**Comments#71 and #72
IEEE P802.3cg/D1.1**

Purpose

- Provide RL measurements and recommendations for Comment#71 and Comment#72

Cl 146 *SC* 146.7.1.2 *P* 114 *L* 49 # 72

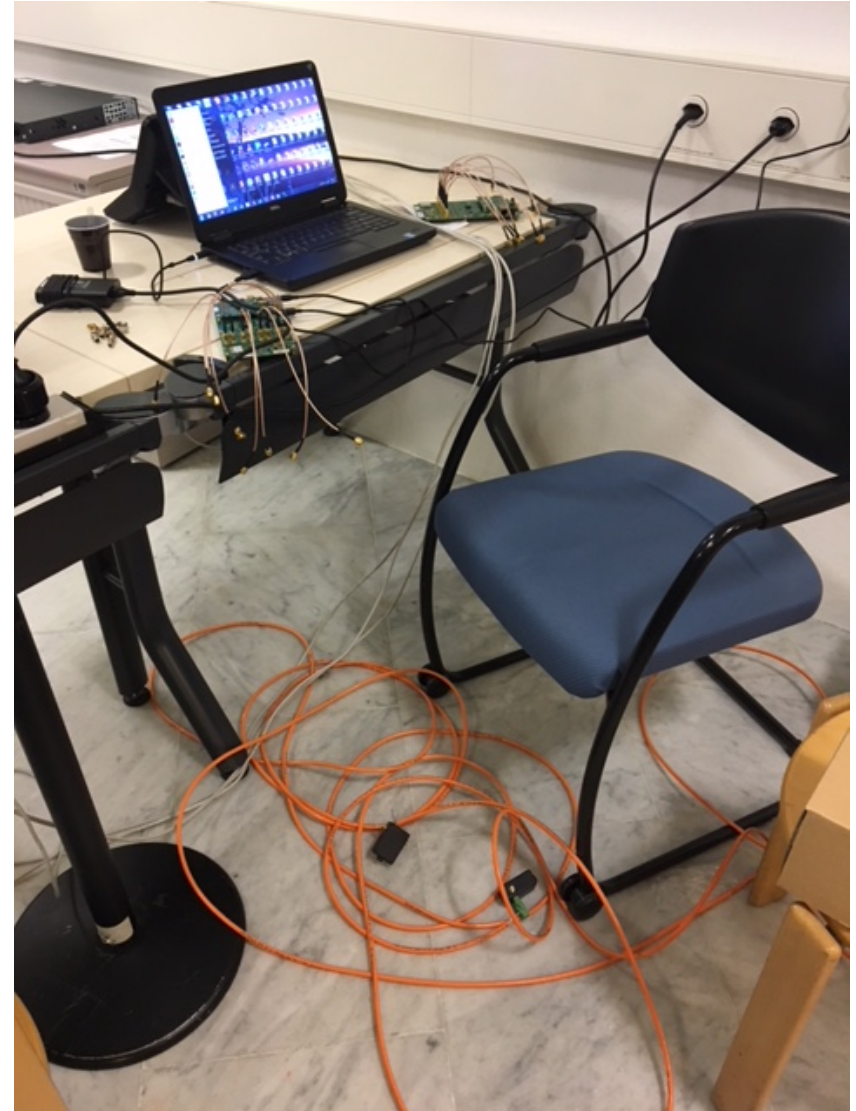
If not agreed the comment presented for draft 1.0 should be adaptet to change RI between 10 to 20 MHz from 19 to 24-5log(f)

PROPOSED ACCEPT IN PRINCIPLE.
See presentation diminico_01_0318.pdf for response.

RL Proposal

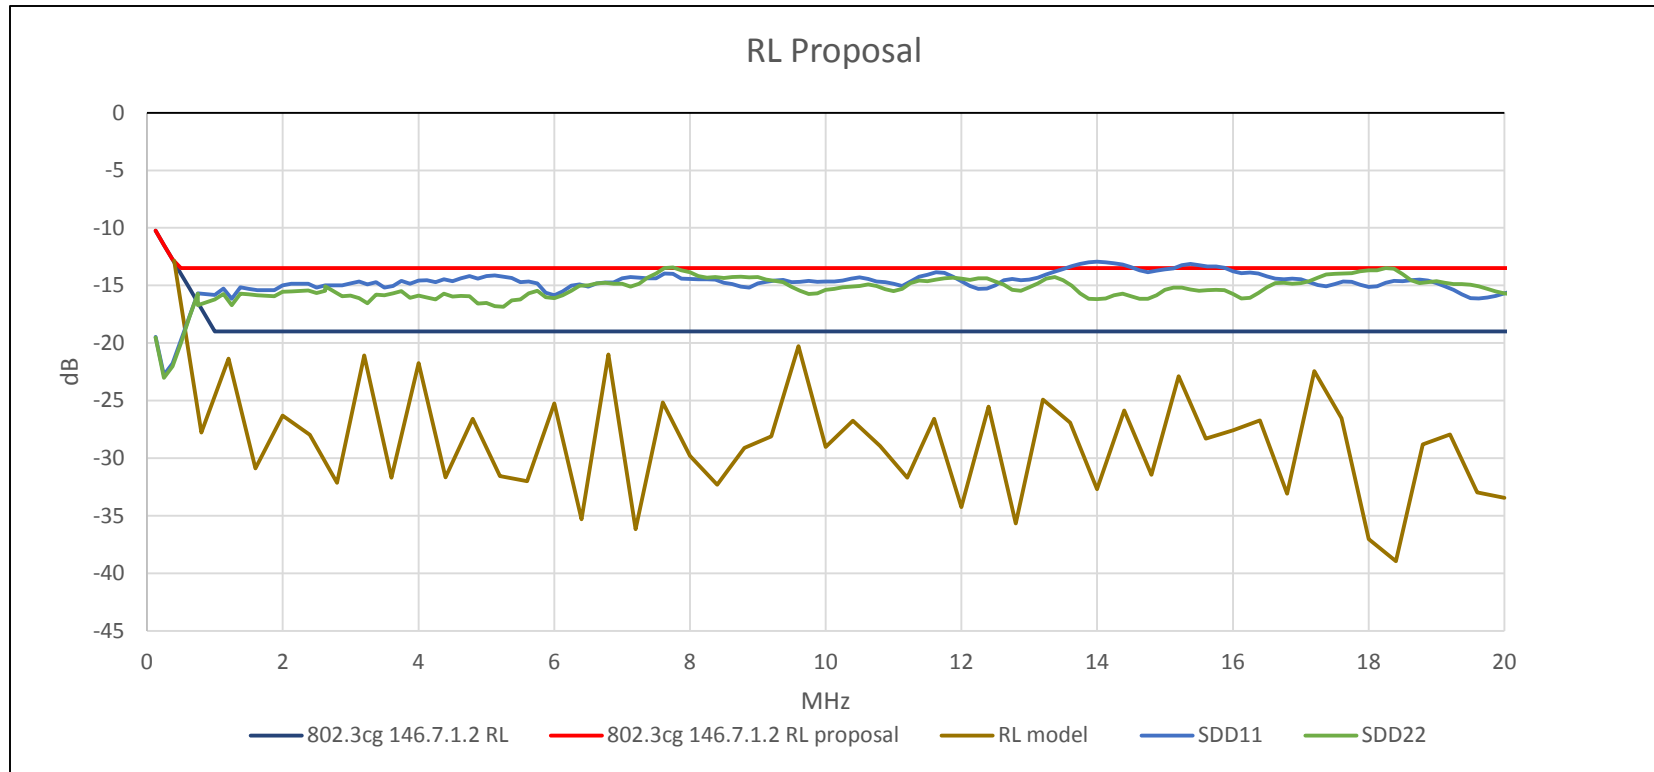
If agreed match values below 1 MHz to: 15 dB down to 0.6 MHz; 9+10f from .1 to .6 MHz

$$\text{Return Loss} \geq \begin{cases} 9 + 9 \times f \text{ dB} & 0.1 \leq f < .5 \text{ MHz} \\ 13.5 & .5 \leq f \leq 20 \text{ MHz} \end{cases} \text{ dB} \quad (146-11)$$

f is the frequency in MHz; $0.1 \leq f \leq 20$
